Proposed Comment Resolution for the MR-O-QPSK PHY

IEEE P802.15

Title: Proposed Comment Resolution for the MR-O-QPSK PHY
Date Submitted: January 18, 2011
Source: Michael Schmidt - Atmel (email: michael.schmidt@atmel.com)
Re: Task Group 15.4g LB59 comment resolution
Abstract: Proposed comment resolution for the MR-O-QPSK PHY
Notice: This document has been prepared to assist the IEEE P802.15. It is offered as a basis for discussion and is not binding on the contributing individual(s) or organization(s). The material in this document is subject to change in form and content after further study. The contributor(s) reserve(s) the right to add, amend or withdraw material contained herein.
Release: The contributor acknowledges and accepts that this contribution becomes the property of IEEE and may be made publicly available by P802.15.

PSD at IF, 100 kchip/s, $(8, 1)_{0/1}$ -DSSS and rate 1/2 FEC

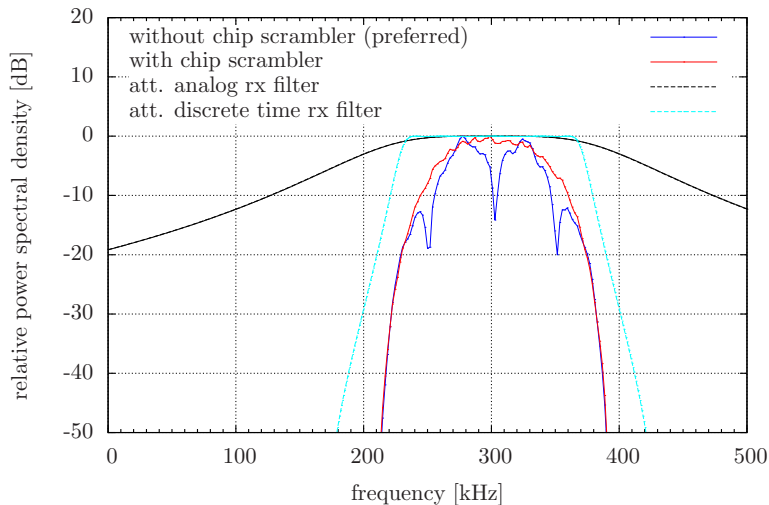
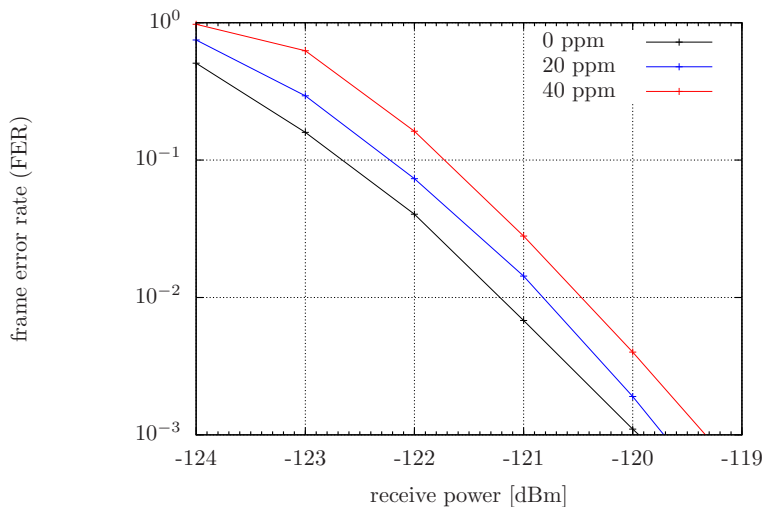
- ▶ Lower data rate should be considered in 470-510 MHz band for improved link budget.
- ▶ Add new data rate of 6.25 kbps with (8,1)-DSSS and rate 1/2 FEC.

- ▶ Add the new spreading mode to all supported frequency bands where narrow band DSSS is applied:

- ▶ true timing sync
- ▶ true frequency offset estimation

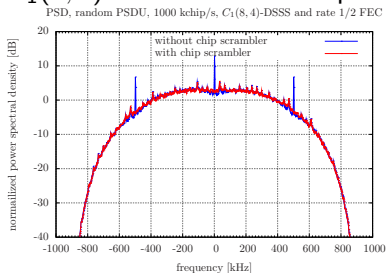
- ▶ Cross correlation of (8,4)-DSSS code is poor
- ▶ Non-coherent detection is not possible
- ▶ Consider (8,4)-DSSS code given in 15-10-0281-04-004g

Minimum Hamming Distance d_{min} :

$$2 = d_{min}^{C_1(8,4)} < d_{min}^{C_0(8,4)} = 4 = d_{min}^{opt}$$

- ▶ $C_0(8, 4)$ is an extended BCH code.
- ▶ The distance properties of the inner block code are less relevant (due to outer rate 1/2 FEC).
- ▶ However, the coding gain of $C_0(8, 4)$ can be exploited for a decision feedback based phase control loop³.
